## Service Kit

SK421-118  
Dated - 23 November 1983

TITLE: MAIN LANDING GEAR SCISSORS WASHER REPLACEMENT

Figure 1. Main Landing Gear Scissors Washer Replacement

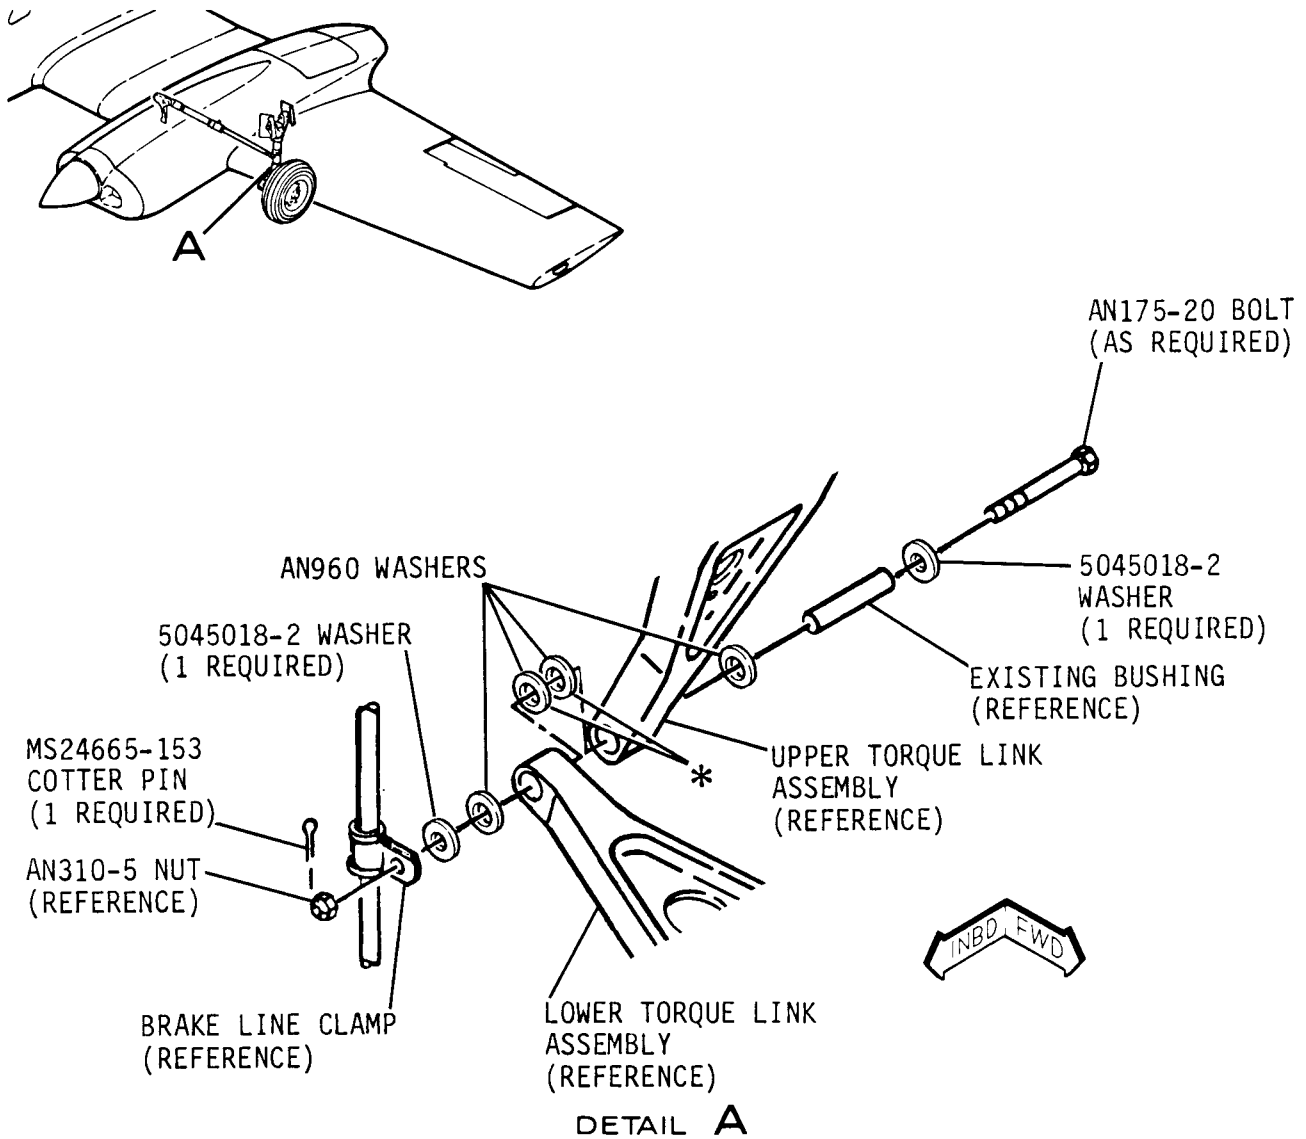
1. Record number of washers installed between torque link assemblies (scissors) before disassembly.
2. Disassemble torque link assemblies as follows:
  - a. Remove cotter pin, nut, washers, bushing and bolt. Discard cotter pin and bolt.
  - b. Visually inspect the torque link assemblies in the area of washer contact. If any damage is evident, replace the torque link assemblies.
3. (Refer to Figure 1.) Reassemble torque link assemblies as follows:
  - a. Install same number of AN960 Washers, positioned on the existing bushing, as before disassembly.
  - b. Install new AN175-20 Bolt with a 5045018-2 Washer under the bolt head.

Do not reinstall the existing washers under head and nut; they are to be discarded.

- c. Install the existing nut with a 5045018-2 Washer under the nut.
- d. Tighten the nut and check for proper cotter pin hole alignment and proper side play of the torque link assemblies. Maintain a 0.004 (minimum) to 0.020 (maximum) side play of the torque link assemblies. Be sure that the spacer washers are centered on the bushing before the nut is being torqued to 100 - 140 Inch-Pounds.

If cotter pin alignment cannot be achieved with existing nut, remove and install a new nut for proper cotter pin/nut alignment.

- e. After proper installation is achieved, secure nut with a new MS24665-153 Cotter Pin.
4. Make an entry in Airplane Log Book stating this Service Kit has been installed.

\*NOTE 1: RECORD NUMBER OF WASHERS AT EACH LOCATION BEFORE DISASSEMBLY AND REINSTALL SAME NUMBER OF WASHERS UPON REASSEMBLY.
